ADDENDUM #1
SAFETY ANALYSIS REPORT
FOR THE
HN-100 SERIES 1 RADWASTE SHIPPING CASK

Revision 1
September 2, 1980

HITTMAN NUCLEAR & DEVELOPMENT CORPORATION
COLUMBIA, MARYLAND 21045

B. Cask Lift Lugs - Modified Design (for use with lifting bar or slings)

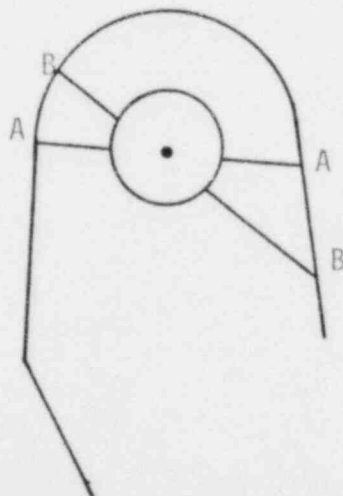
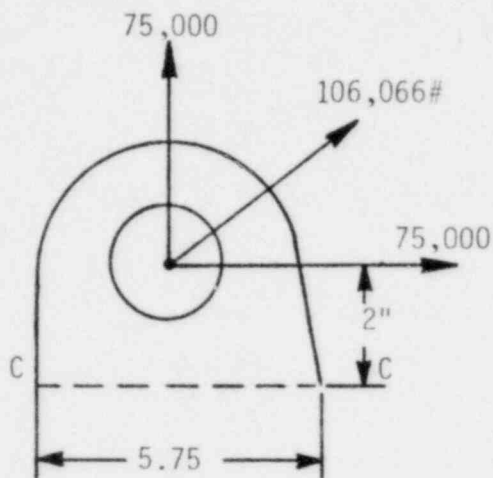
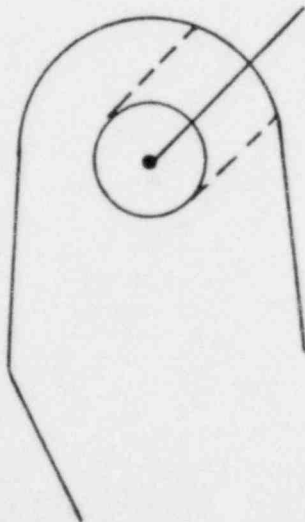
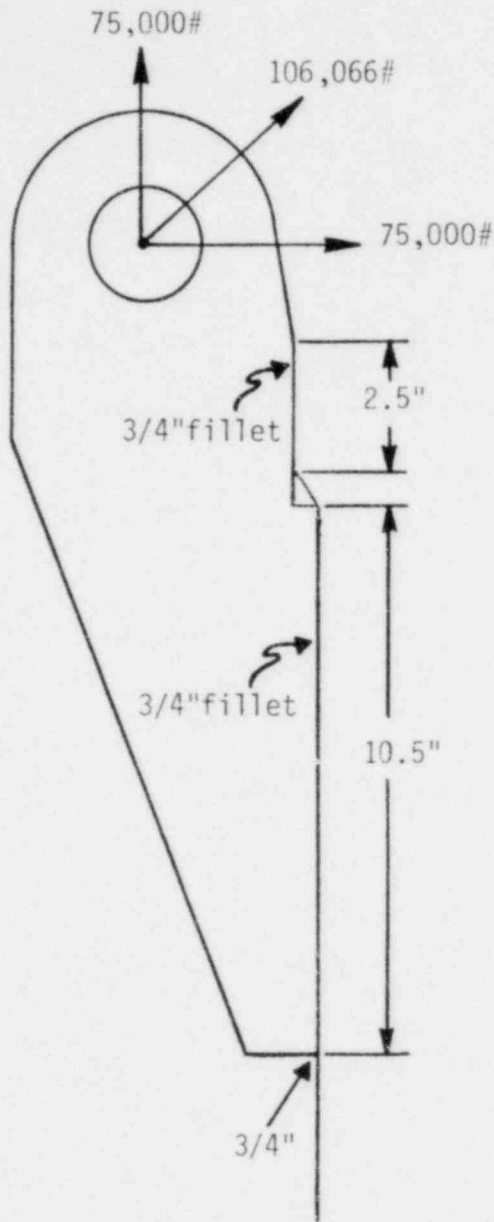
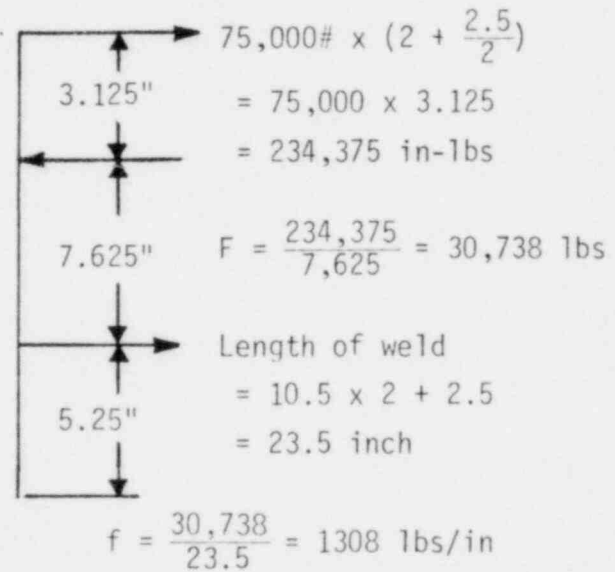
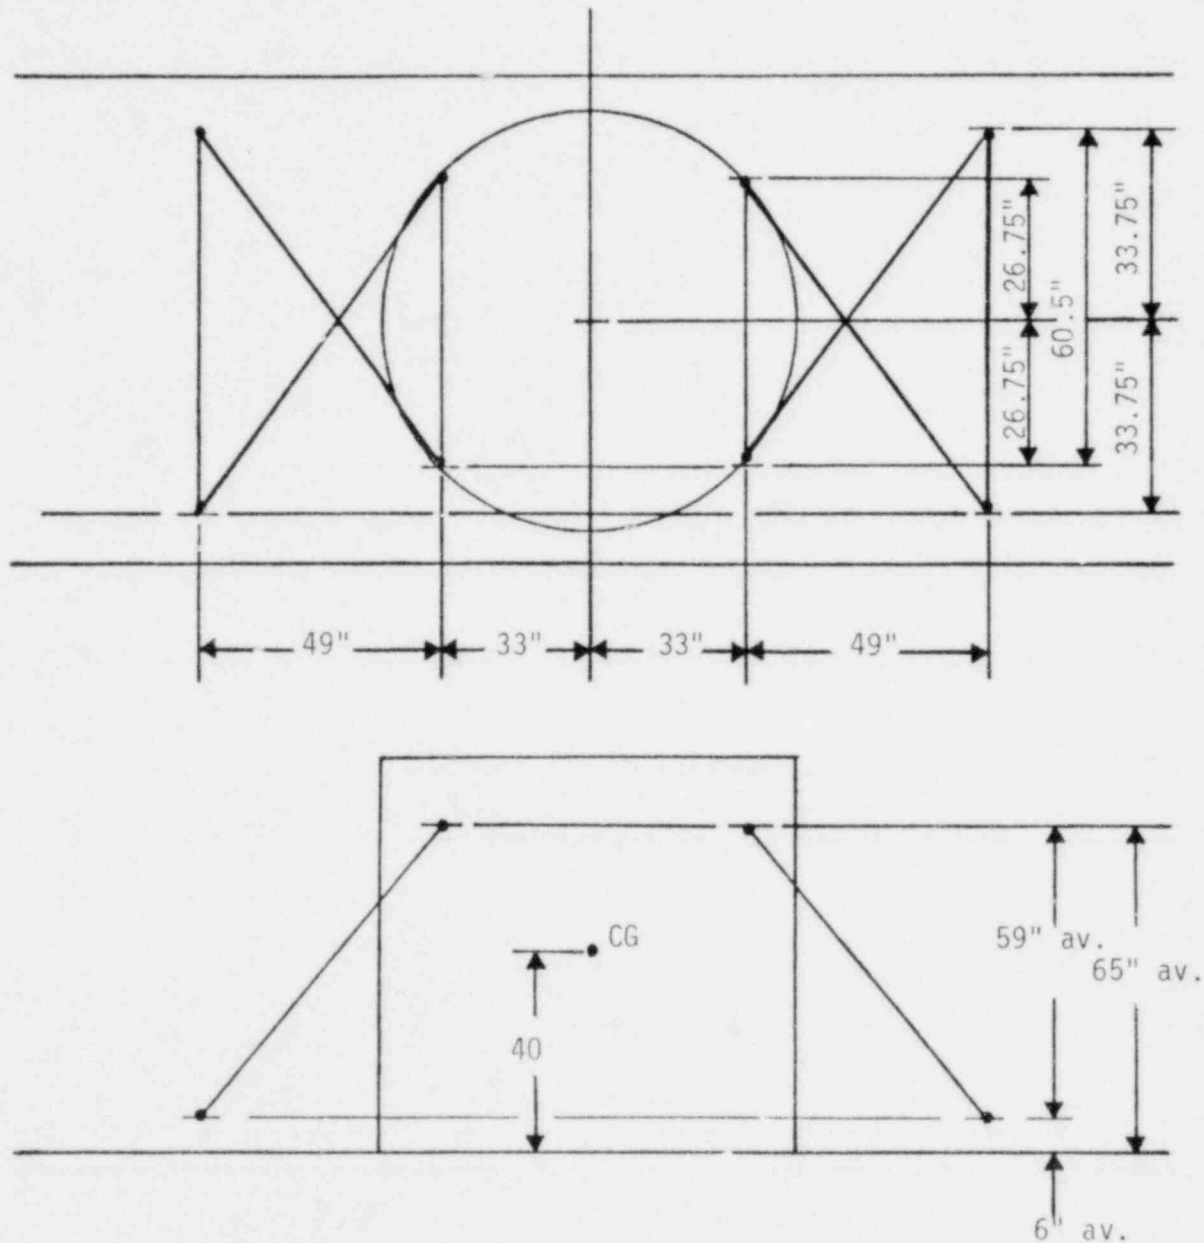
Revision 1 to this addendum contains the analysis for modified lifting lugs to be installed on the HNDC HN-100 Series 1 shipping casks to allow the use of shorter lifting cables. Packages in the series are constructed of ASTM A516 Grade 55, ASTM A516 Grade 70, ASTM A515 Grade 70 steel. The safety analysis has been revised based on the use of ASTM A516 Grade 55 steel which has the lower yield and ultimate strength of the steel used in the packages. The tiedown analysis has been revised to combine the longitudinal, transverse and vertical loads in terms of the total tensile force on the cable and calculates the stresses on the shell based on the vertical and total horizontal components on this tensile. The analysis concludes that the package can be operated safely with a maximum weight of contents of 14,500 pounds and a gross package weight of 50,000 pounds.

Weight of cask = 50,000 lb

Number of lift lugs = 2

$$\frac{50,000 \times 3}{2} = 75,000 \text{ lb}$$

$$= \frac{75,000}{\sin \theta} = 106,066$$

$$\text{Stress} = \frac{75,000}{8.59} = 8727 \text{ psi}$$

$$\text{Safety Factor} = \frac{30,000}{8727} = 3.43$$

$$\text{Safety Factor} = \frac{30,000}{16,788} = 1.79$$

$$\text{Safety Factor} = \frac{18,000}{7714} = 2.33$$

Safety Factor = $\frac{6120}{2939} = 2.08$

$$\text{Safety Factor} = \frac{30,000}{21,213} = 1.41$$
